**ADDENDUM  
NO. 3**

**September 30, 2025**

**VALE FACILITY ADDITION/RENOVATIONS AND  
MAINTENANCE/IT FACILITY PROJECTS**

**Addendum Three (AD.03)** to the drawings and specifications prepared by Gibraltar Design for **Valparaiso Vale Facility Addition/Renovations and Maintenance/It Facility and Related Work** for Valparaiso Community Schools, Valparaiso, Indiana.

9/24/2025 2:38:30 PM J:\Revit\25-113 Vale Addition and Renovation - ARCH R25\_ennocaulley\CGAD.rvt

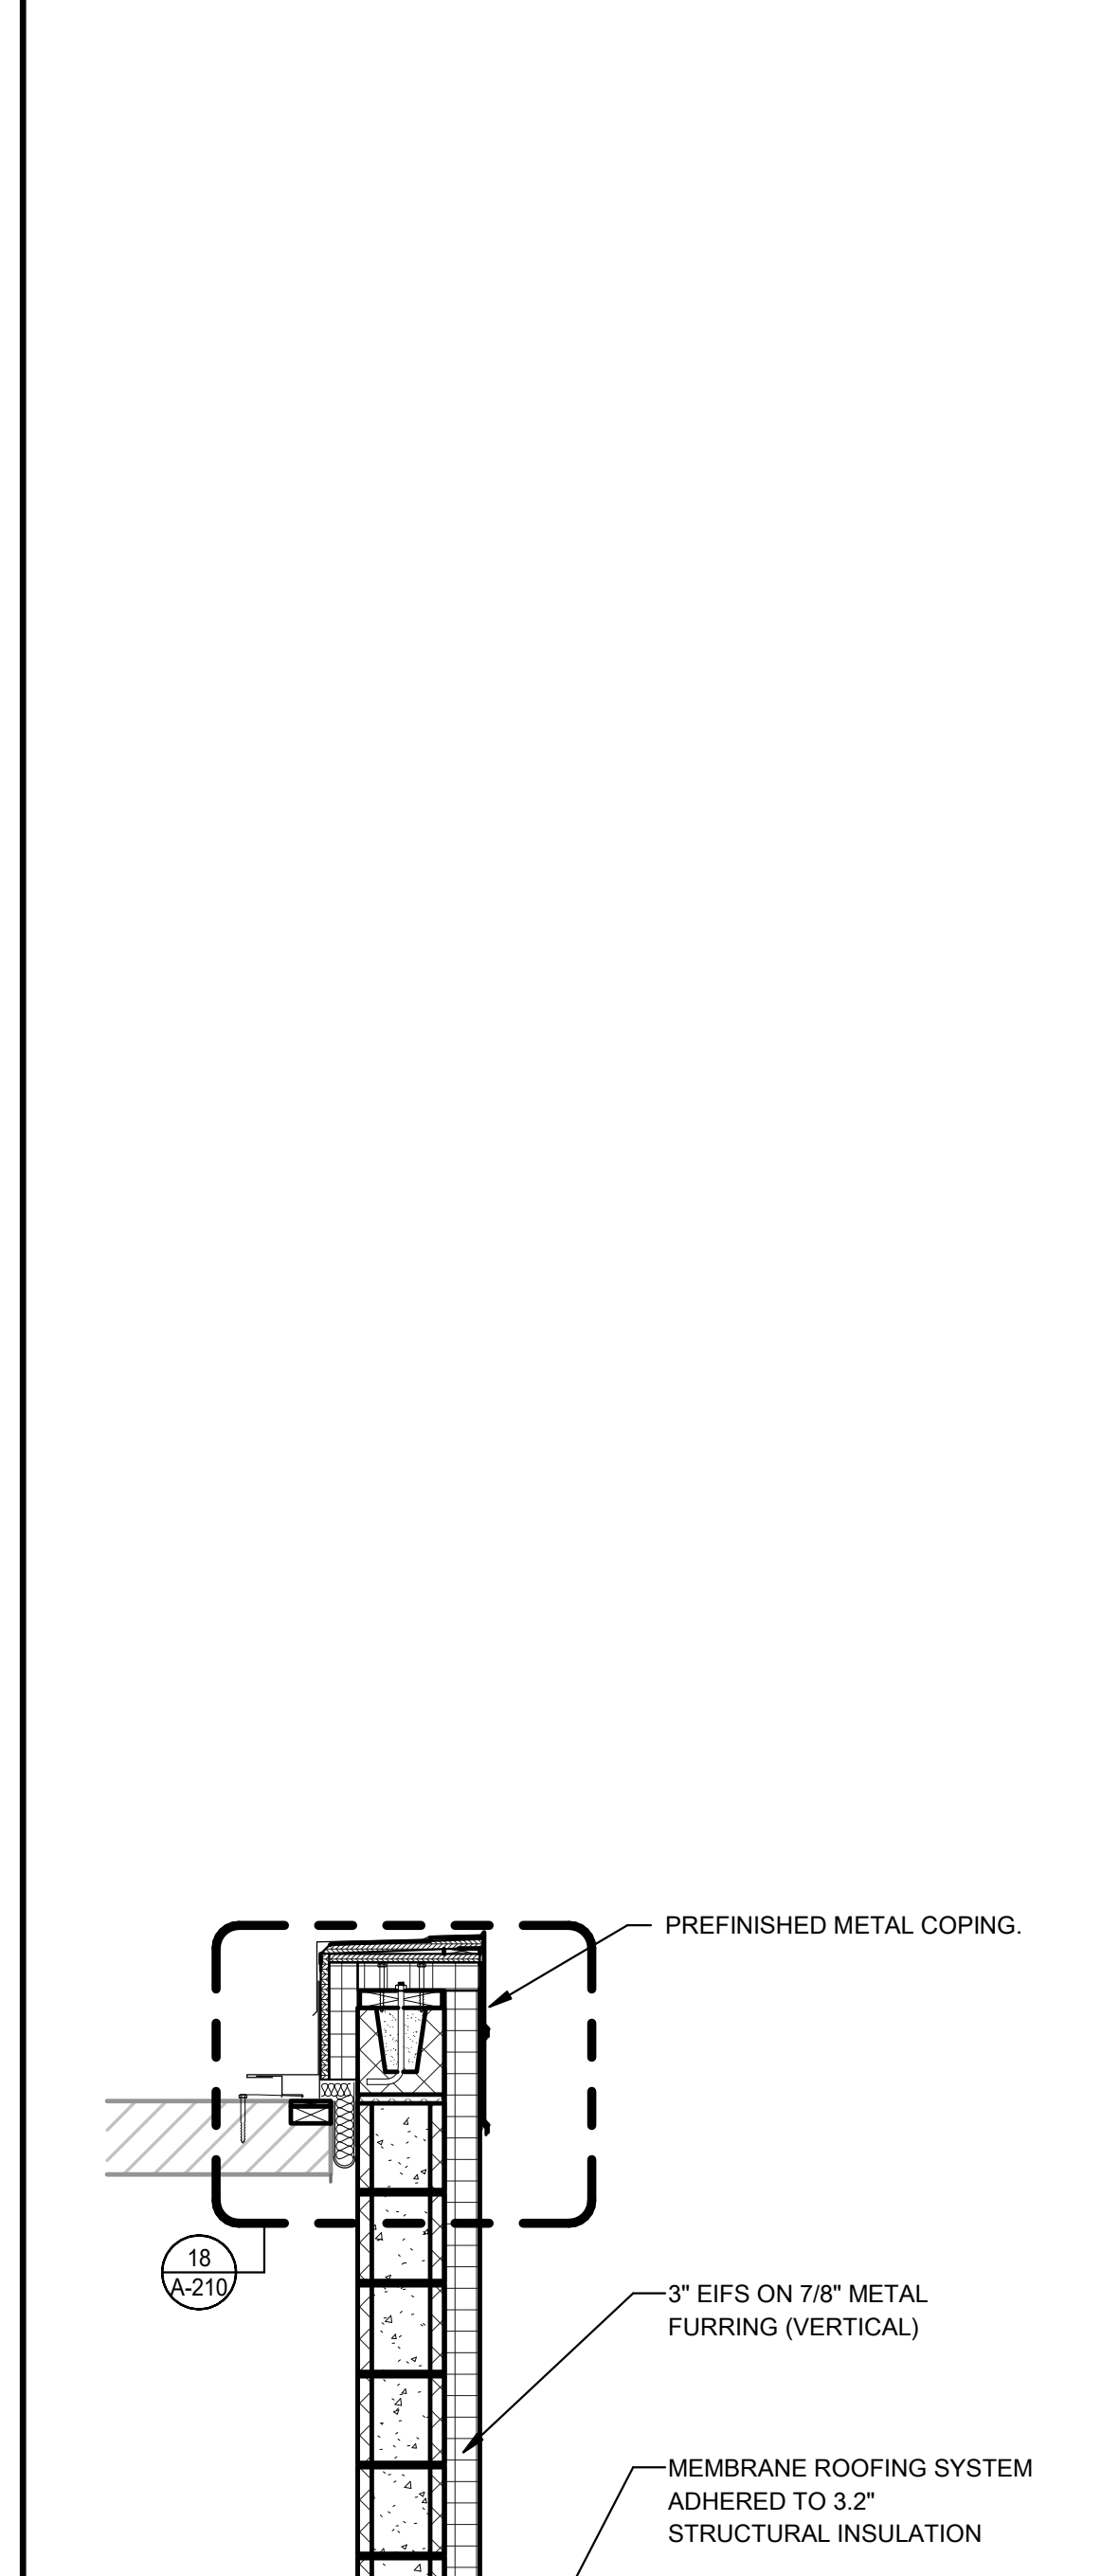
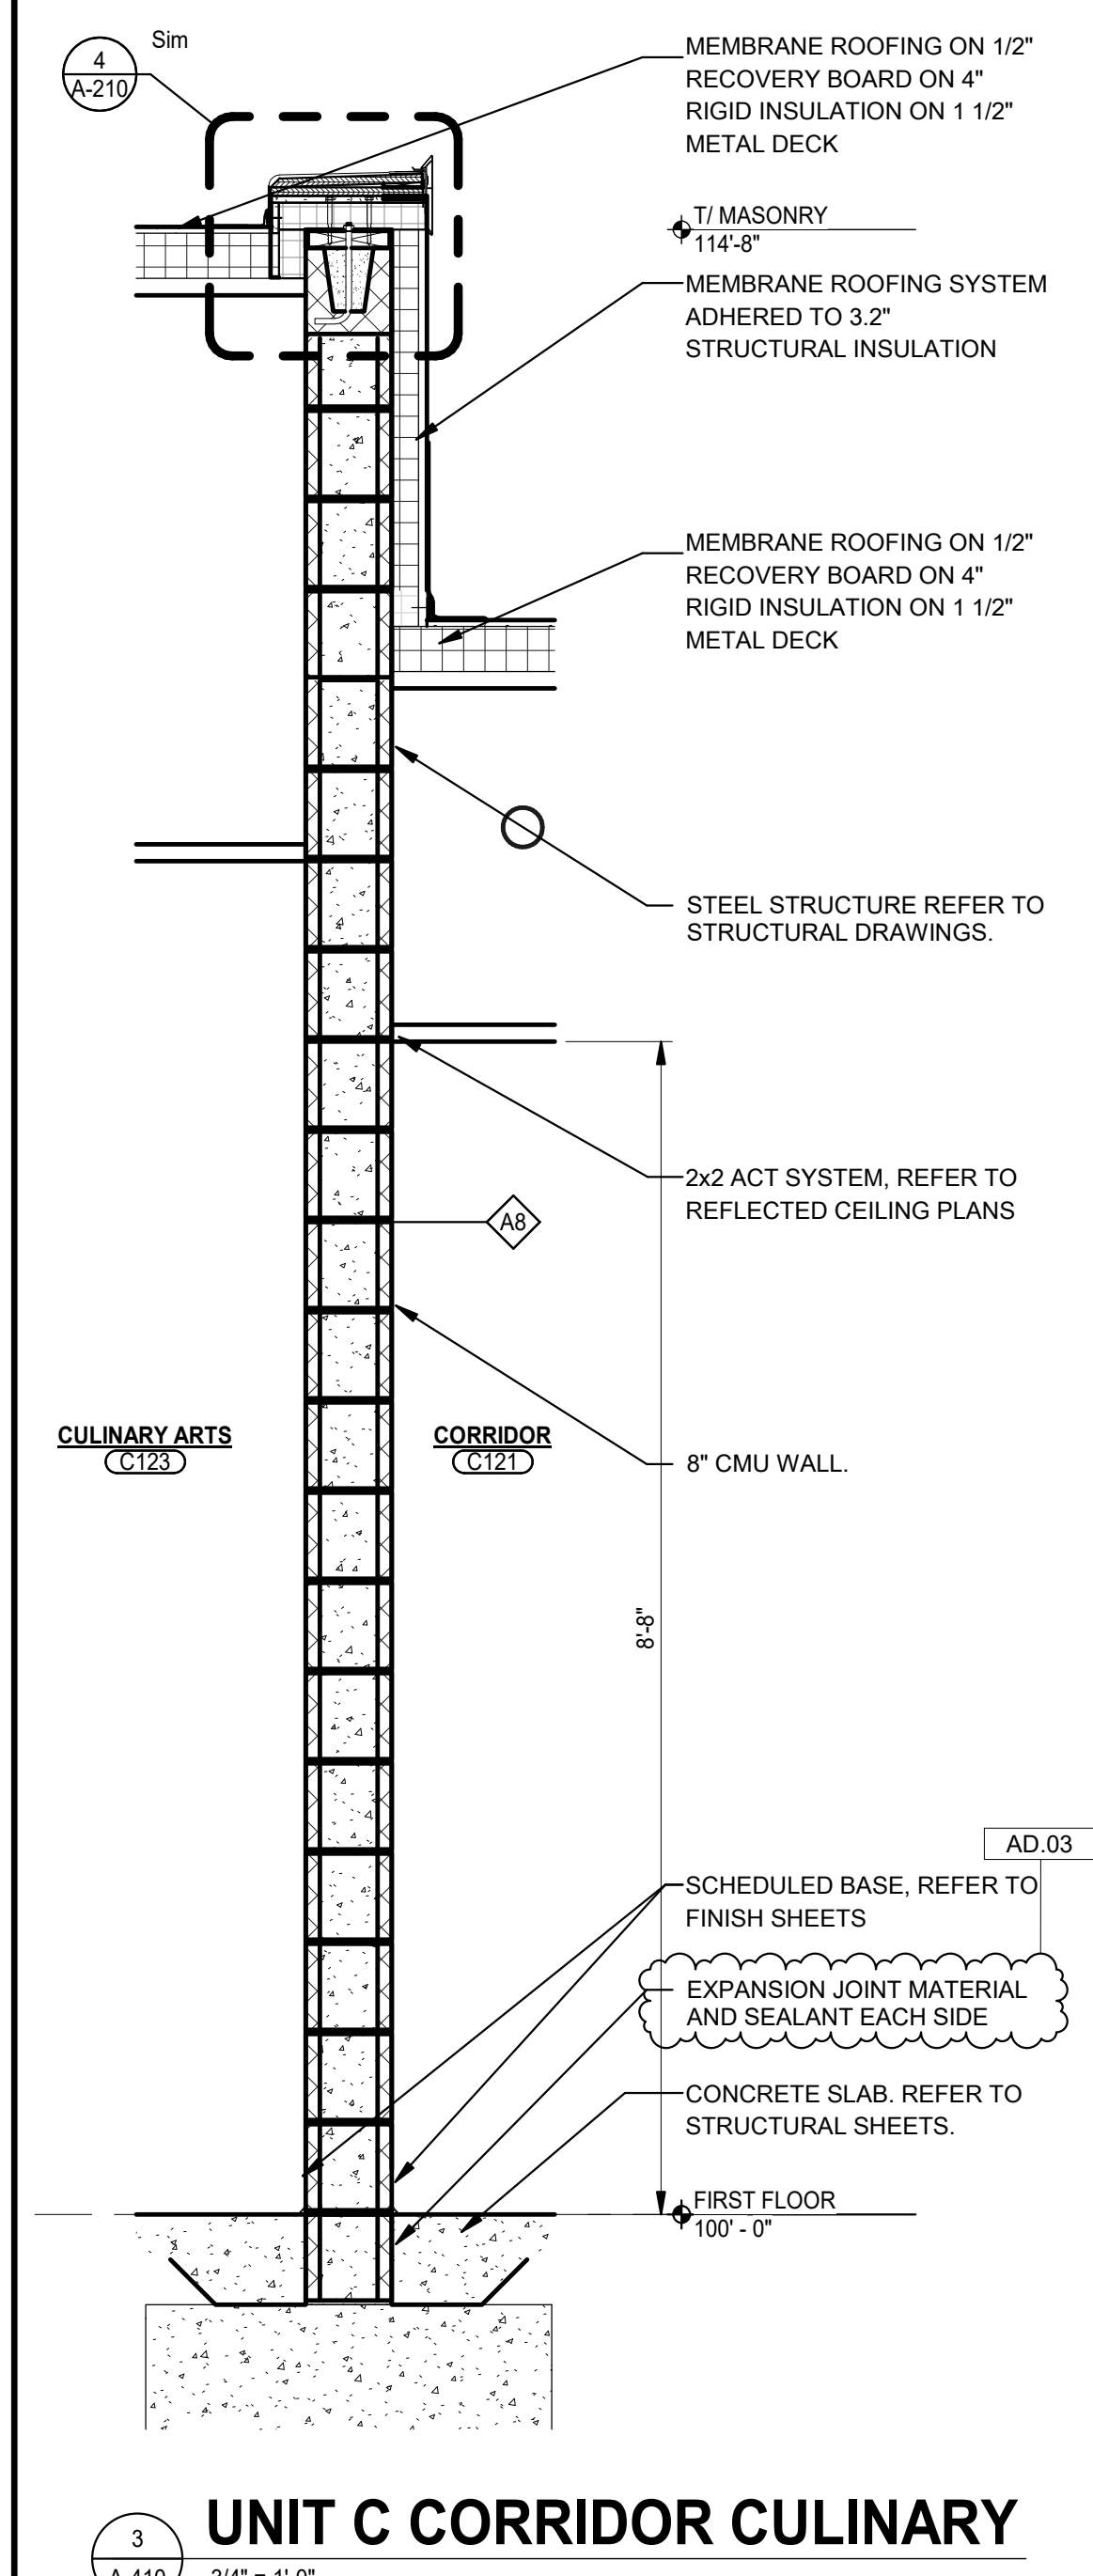
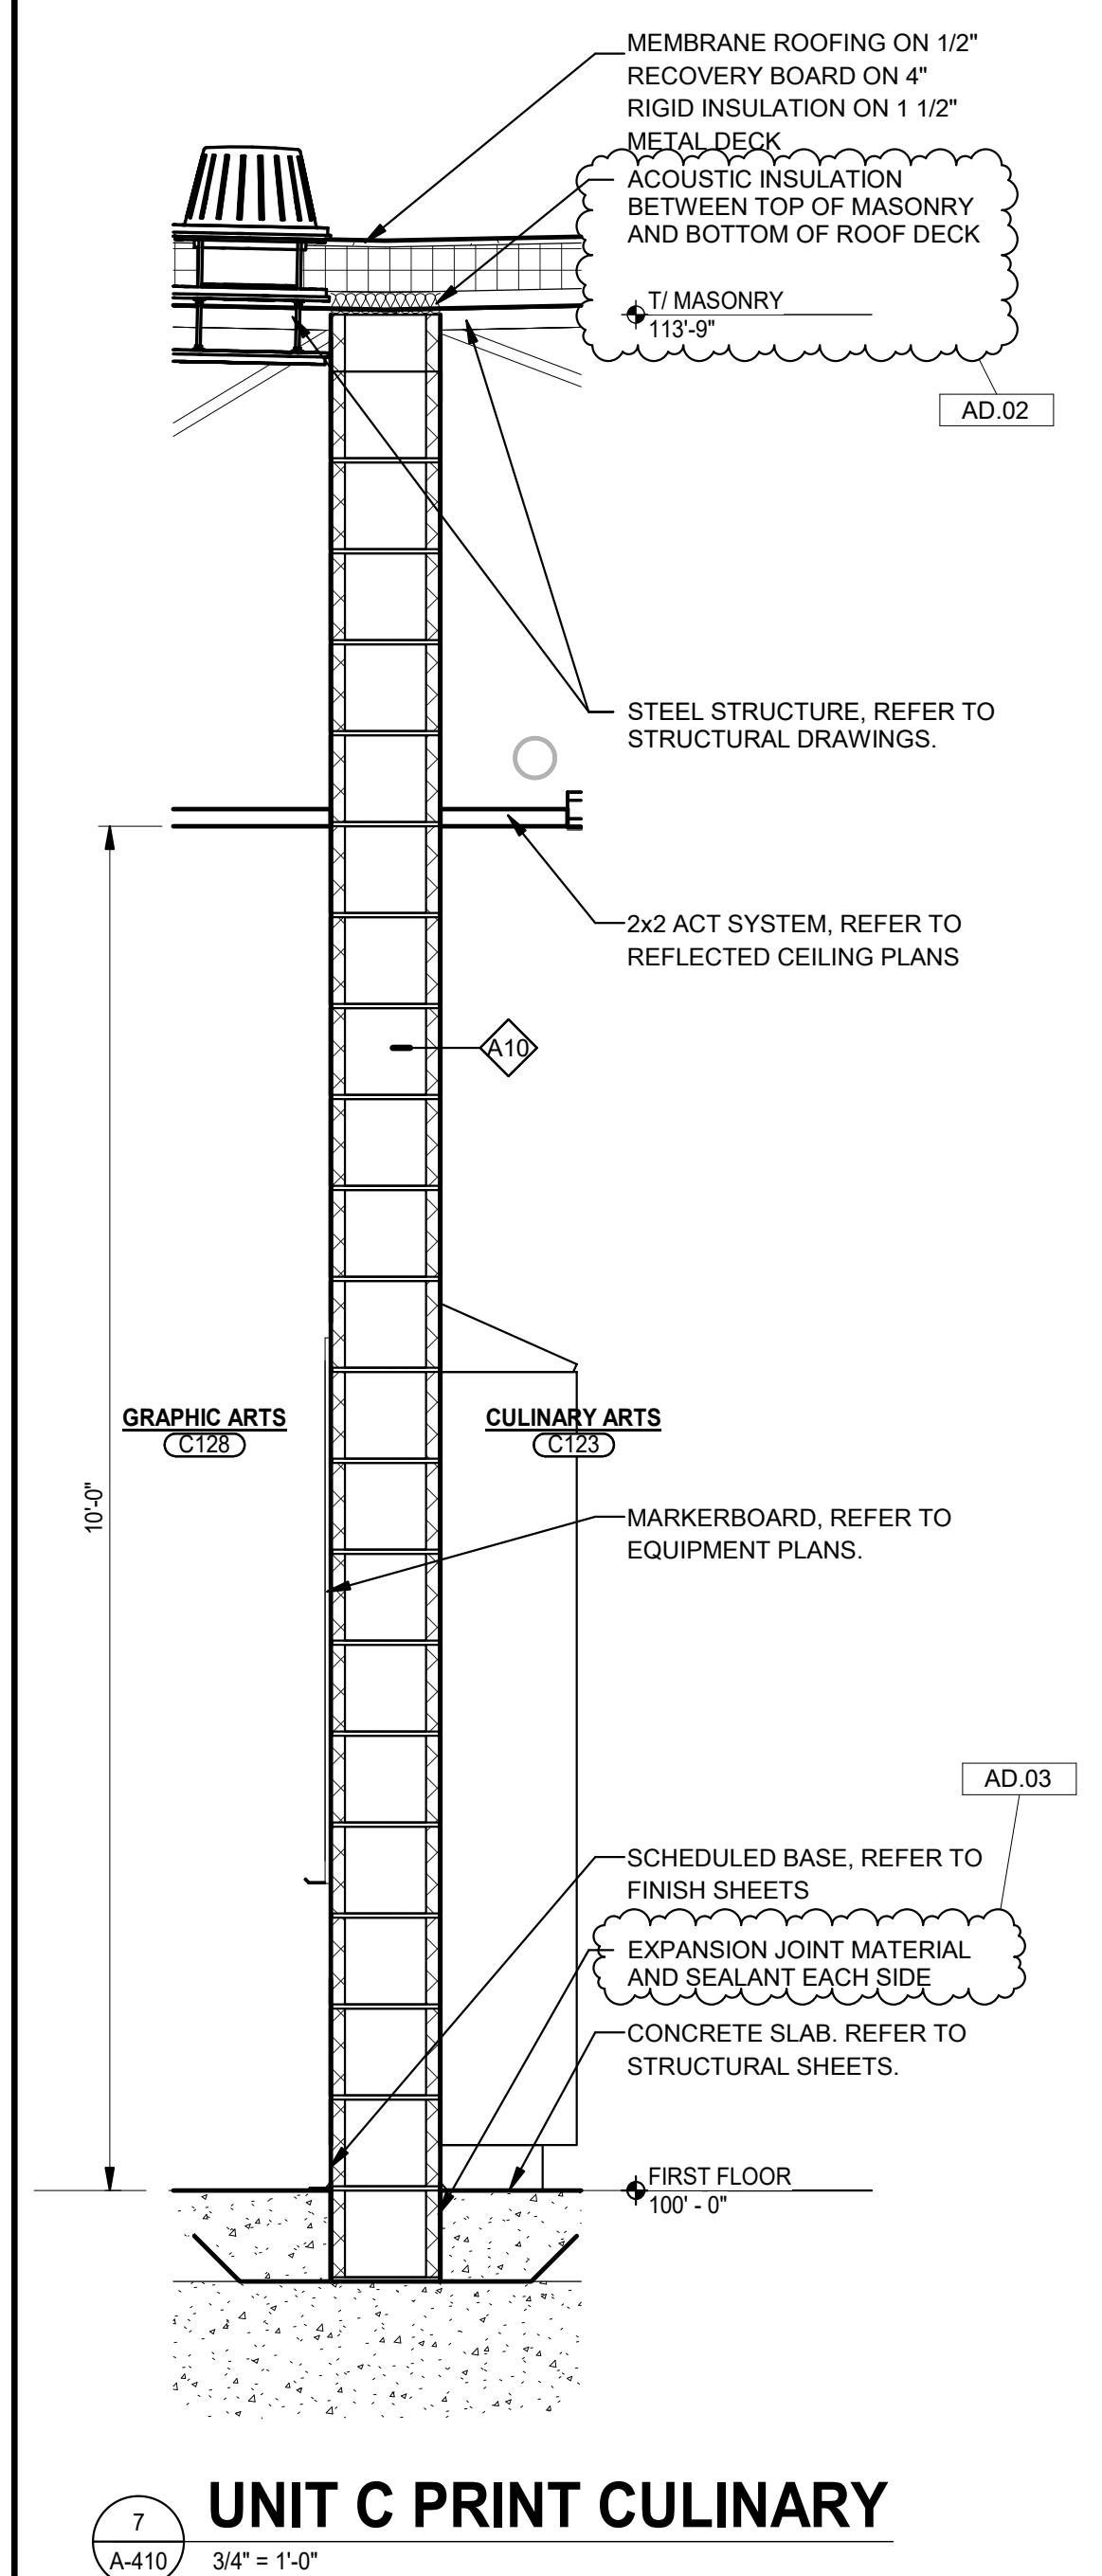
- A. Refer to revised, full-size drawing, included in this Addendum, for revisions.
  - 1. Added / Clarified expansion joints at slab to wall conditions.
  - 2. Clouded bottom of new exterior walls to refer to detail 1/A-410.
